**TITLE: CHANGE OF ZONE NO. 16018**
(6111 Morrill Avenue)

**LINCOLN/LANCASTER COUNTY PLANNING STAFF REPORT**

**PROJECT #:** Change of Zone No. 16018, Planned Unit Development (PUD)

# St. Patrick Church PUD

A5 PUD Application - Overall Site Plan

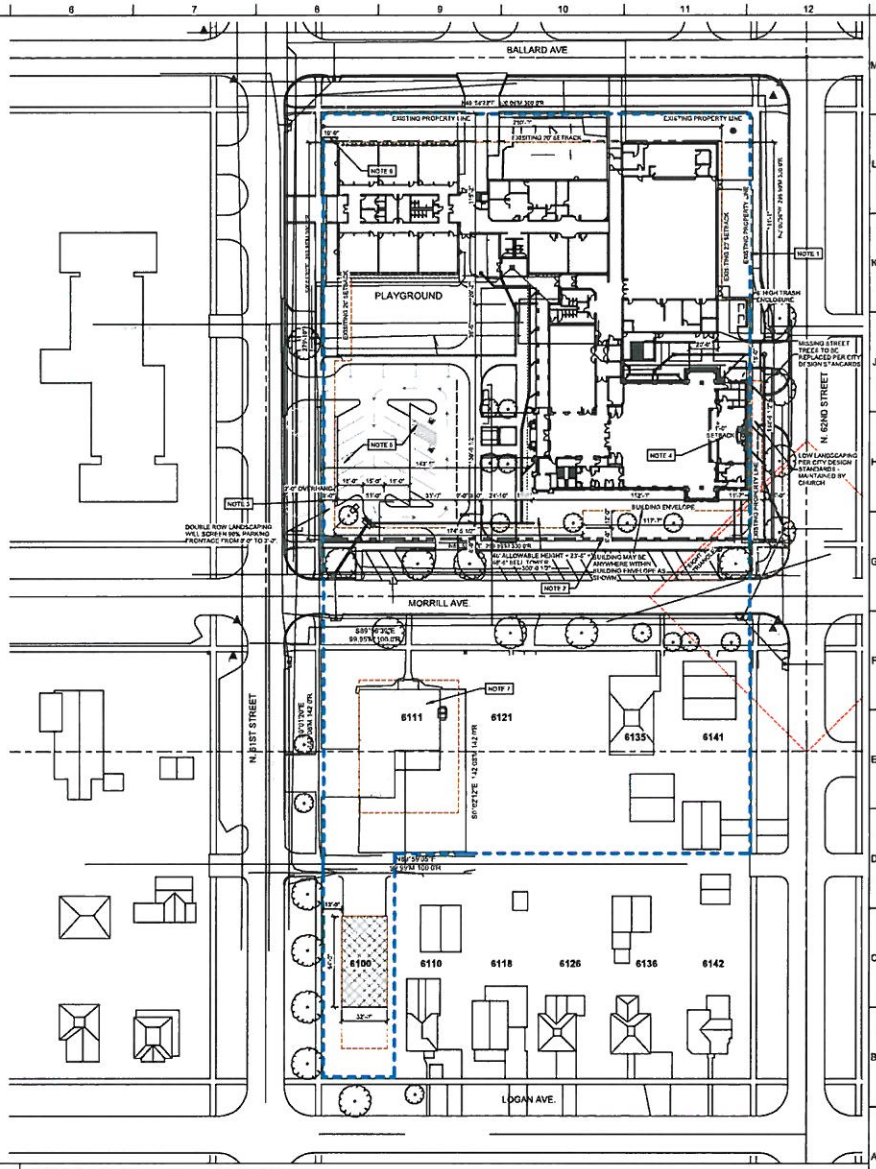
1.1 Add note to Sheet 1:
    "6121, 6135, and 6141 Morrill Avenue (Lots 1-4, Block 61) are subject to regulations of the R-4 zoning district and may also be used for parking without a separate Special Permit. Setbacks of 8 feet on Morrill Avenue and N 62nd Street are permitted for parking if screening is provided that doubles requirements of the Design Standards for Screening and Landscaping. Parking lot layout shall be approved through Administrative Amendment."

1.2 Separate waivers from Sheet 1 Specific Notes and list under "Waivers" heading.

1.3 Add waiver note: Front yard setback of 13 feet along N 61st Street north of Logan Avenue as shown on plan.

1.4 Show dashed line along 10-foot setback in northeast area of site.

1.5 Label trees on site plan. Label existing trees as "Existing to Remain". Label new trees as the following:

State Street Miyabe Maple (east side of N 61st Street)
    Northern Red Oak (north side of Logan Avenue)
    Hackberry (south side of Morrill Avenue)

| Agency Name | User Name | Review Cycle | Review Status | Comments | Assignment |
|---|---|---|---|---|---|
| Building & Safety | christy eichorn | 1 | Corrections Required | 1. Is this PUD 3 acres?<br><br>2. How will the signage be regulated for the commercial building?<br><br>3. Notes should be added to the General notes stating waivers and setback adjustments.<br><br>4. Don't show building envelopes only lot lines and setbacks. | First In Group |
| Parks & Recreation | kevin saathoff | 1 | In Review | 6/9/16 -<br>As per your e-mail, let the applicant know that they need to add the trees I identified to their landscape plan.<br>kls. | Individual |

1 Building Elevations

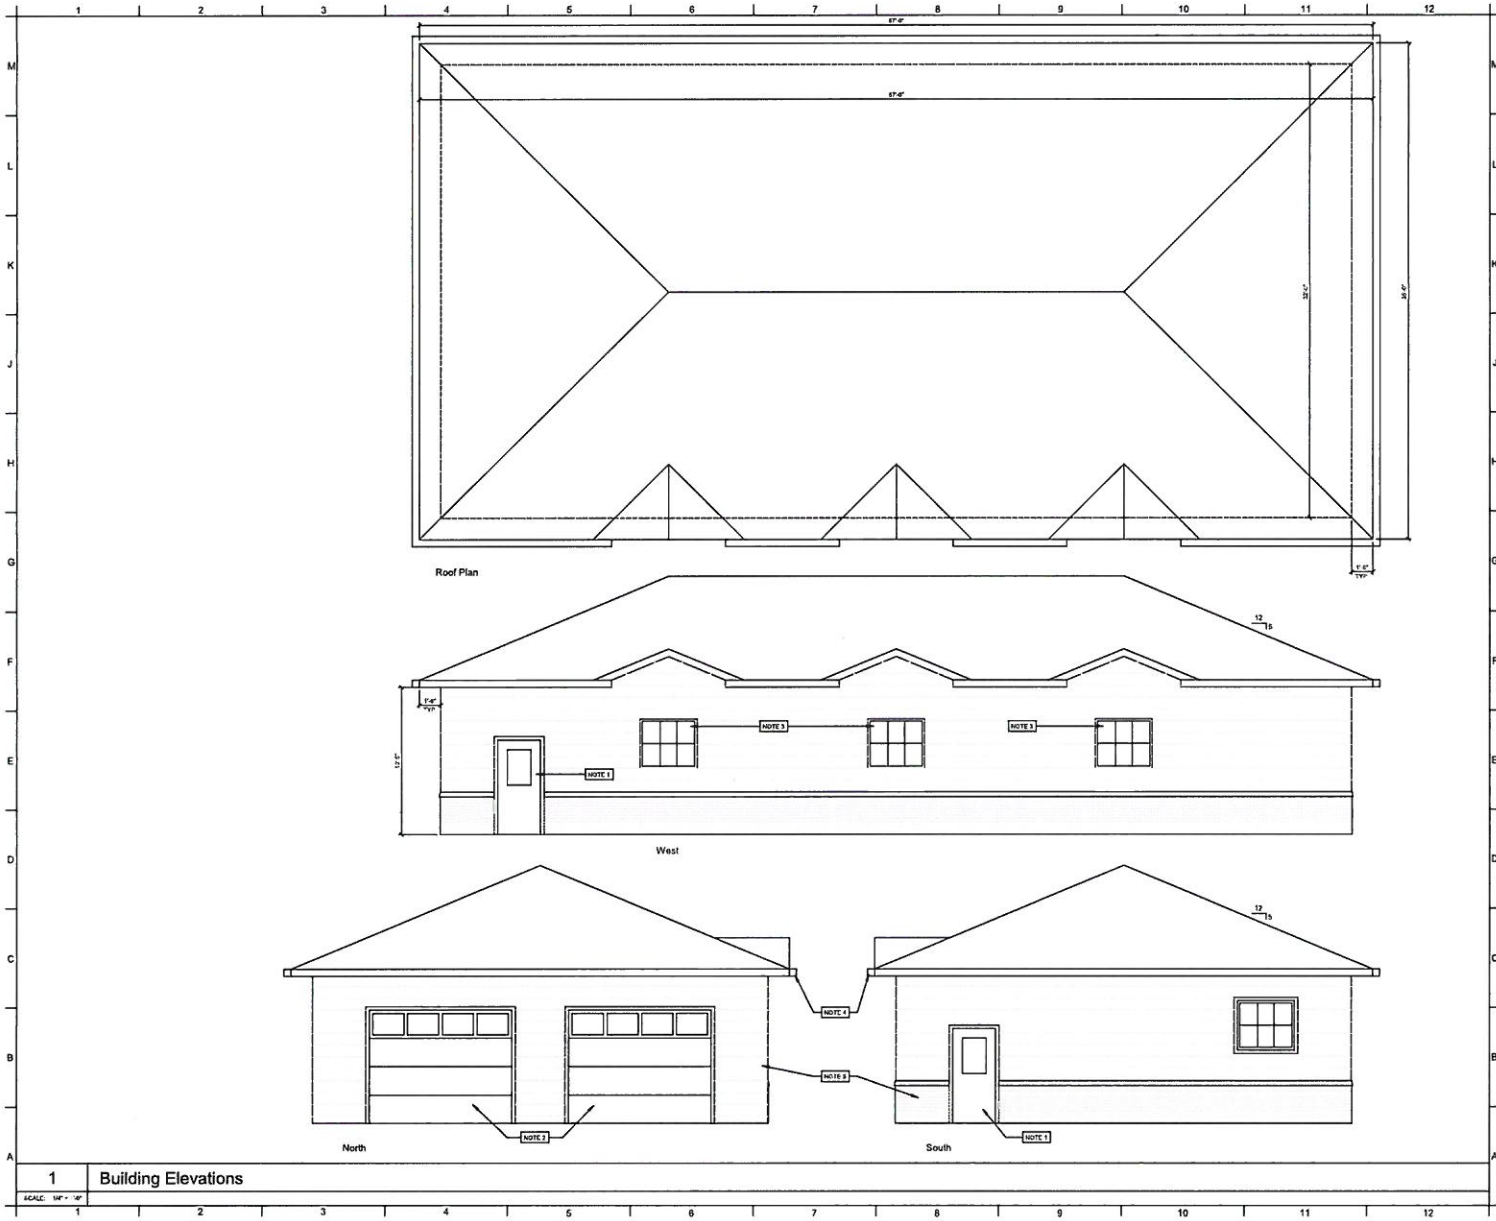
2. Proposed building on Sheet 3 shall meet Neighborhood Design Standards prior to final plan approval.

| Agency Name | User Name | Review Cycle | Review Status | Comments | Assignment |
|---|---|---|---|---|---|
| Historic Districts/Capitol Environs | edward zimmer | 1 | Corrections Required | New garage/storage building does not meet Neighborhood Design Standards as required in R-4.<br>Lacks orientation (porch, windows) to Logan Ave. and relief on west street frontage. | First In Group |
